Draft Publication Moderation Policy Reply to an OET Inquiry Response Currently Displaying Inquiry Tracking Number: 730030

First category: Second category: Third category: Subject: FCC ID Label for Cochlear Nucleus 8 Sound Processor Inquiry: Dear Sir or Madam,

Artwork for Engraving

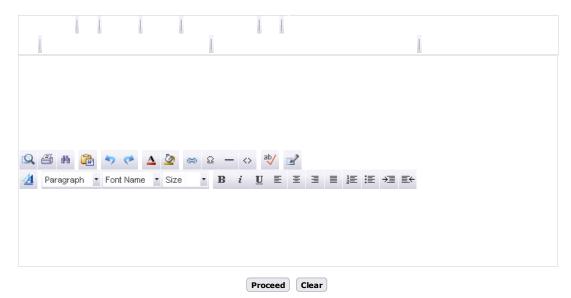
The available surface area for marking on the inner spine is very limited. As shown in the artwork for engraving attached, the unique device number (#101016XXXXXXX) and build standard letter (Y), whose fond sizes are smaller than four-points, have already occupied most of the inner spine surface area and thus leave no surface area for the FCC ID (WTO-CP1110).

As per section 3 of FCC General Guidelines for labelling, 84748 D01 General labelling and Notification v09r01, we plan not to mark the FCC ID on the case, instead, to include the FCC ID in the user guide and also place it either on the device packaging or on a removable label.

Please confirm if our proposal for marking is acceptable so that the TCB can proceed the certification.

Hello, Yes, we can accept pursuant to 2.925(f) of the FCC Rules.
